M&C No. 88-4

CDV-700 RADIOLOGICAL SURVEY METER PROTECTIVE DIODES AND CAPACITORS

Figure 6-5. Schematic Circuit Diagram

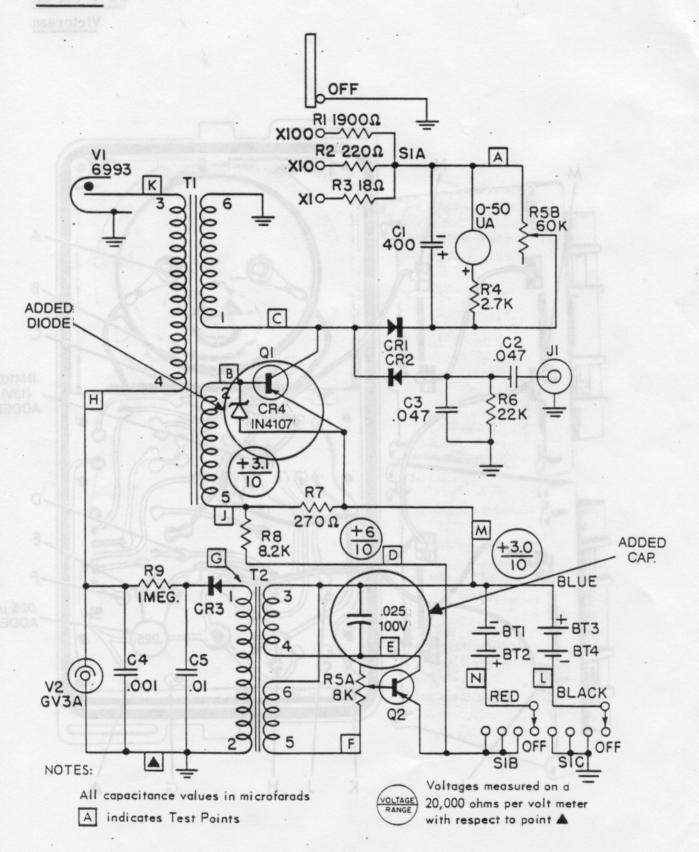
- Install one ea. 1N4117 Diode (21103) between the emitter to collector circuit of QI in the Victoreen V-700-6 and 6A. Also, one ea. .05uf capacitor (21113) across winding 3 & 4 of transformer T2 (see attachment).
- Install one ea. Zener diode 1N4107 (21104) across the emitter to base circuit of Q1, and install one ea. capacitor .025uf (21115) across winding 3 & 4 of T2 (see attachment).
